**820 Esquimalt Road
Esquimalt, BC**

Re: Development Permit 826 Esquimalt Road

826 Esquimalt Road: Verde Condominiums.

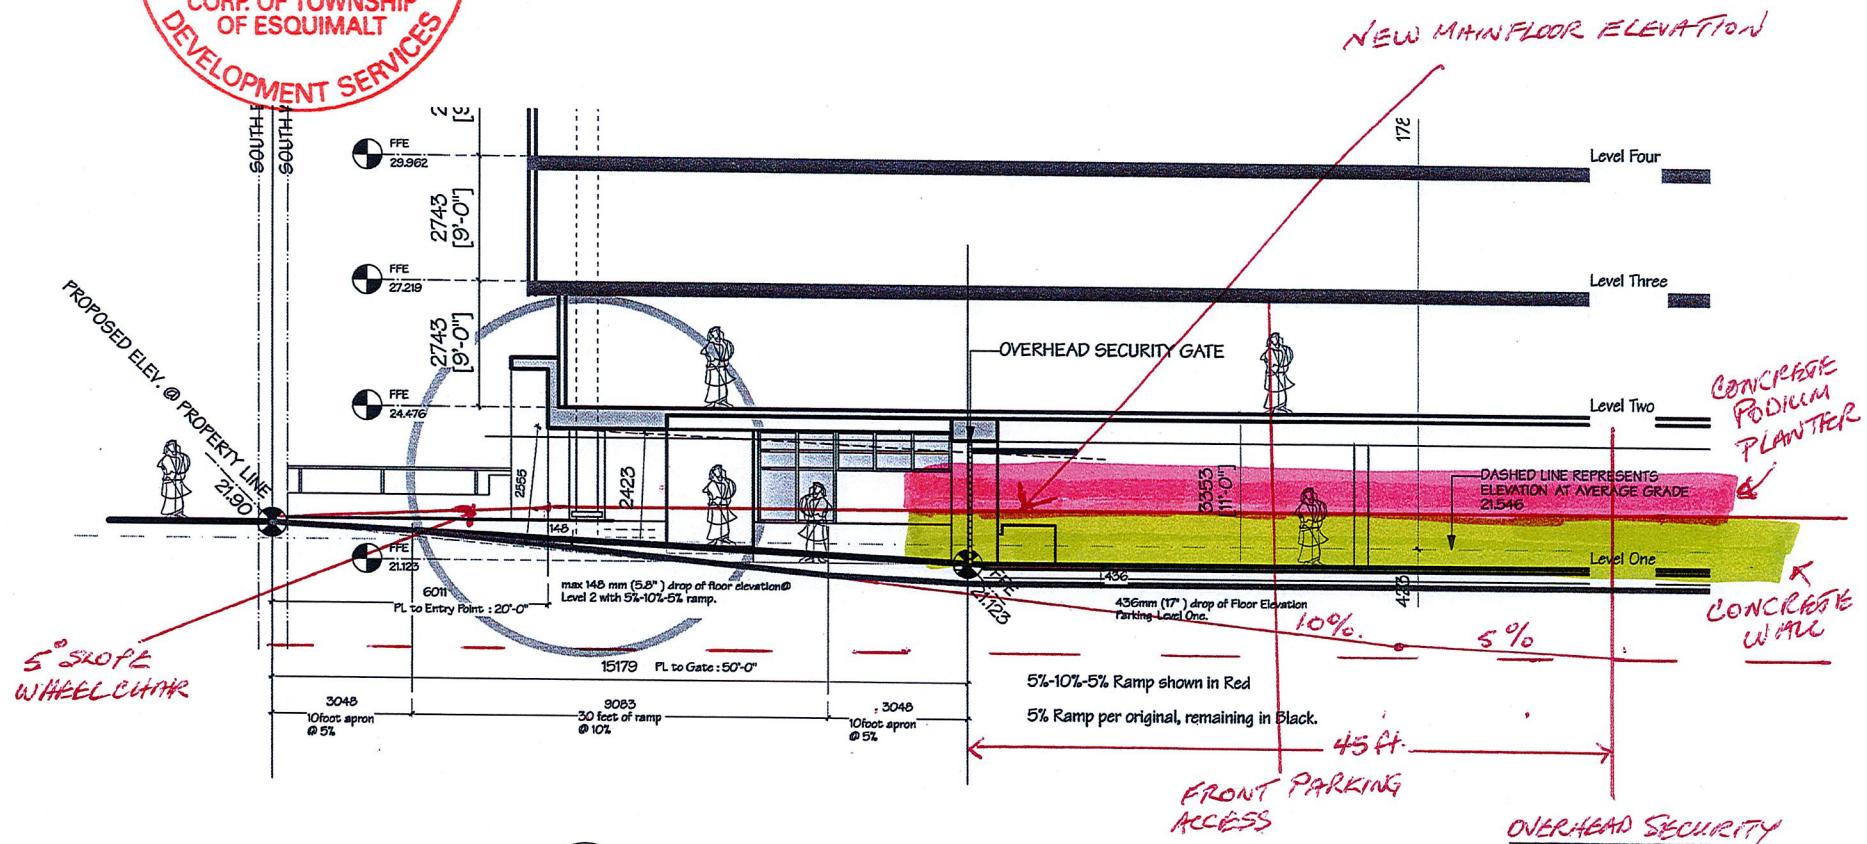
1. East and West Podium Planters have been recessed entirely into the parking structure and the above slab concrete retaining wall/railing has been replaced with a railing along each elevation. Replacing concrete with railings has reduced the "apparent" height of the parking structure by 25% from the east and west elevations and provides a better opportunity for plants to cascade over the side of the parking structure.

2. The expansion of the East Parking Grill has provided for a greater amount of planting area from within the parking structure that will allow more greening of the East Parking area. (The final amount of grill expansion will be dependent on structural engineering requirements)

3. The southeast grill area that separates the visitor surface parking from the below slab visitor parking has been increased in size to incorporate the entire available area that is not required for structural concrete posts

Part Section at Port Cochere Entry to parking Level One

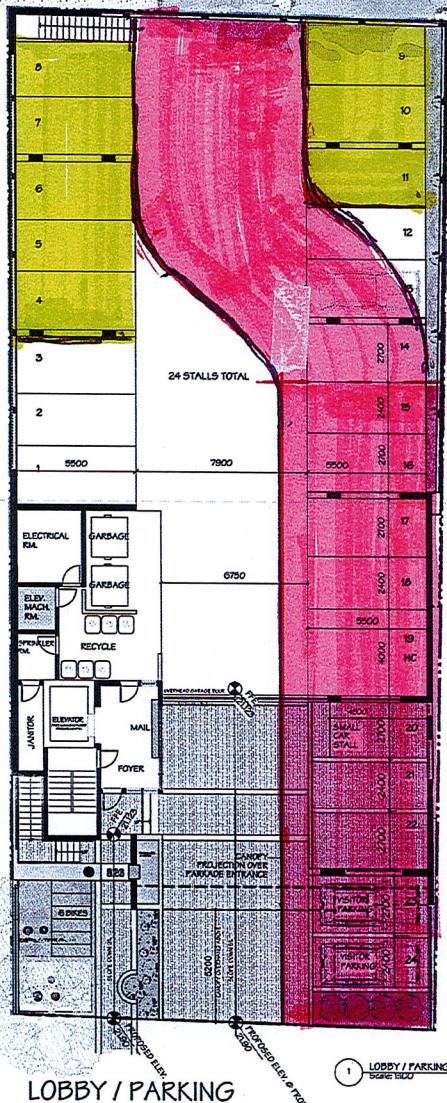
The attached diagram shows what changes occur when bringing the main living floor to 1ft above sidewalk grade (minimum necessary for wheelchair access) and pushing parking completely underground when considering that at a minimum good design should incorporate the following:

- Minimum of 3m of apron at 5% slope at intersection of property line
- 3m of apron at 5% slope at intersection of ramp with parking level
- Maximum slope of 12% for parking access ramp from 5% apron

Almost half of the very attractive front elevation is lost along with nearly half of the podium landscape area. The neighbouring property to the east (already artificially sunk below sidewalk grade) would look at a driveway for 1/3 of the length of the building before it was lost underground and 8ft of concrete wall (above ground parking structure and above podium concrete planter) thereafter. Parking would be reduced to 8 units. Certainly not an improvement.

95 FT SECTION LOST TO PARKING *

* FOLLOWING ENTRY THROUGH SECURITY GATE REQUIRED 32FT FOR
JOG IN PARKING ACCESS TO BRING ACCESS INTO CENTRE OF PARKING
AREA.
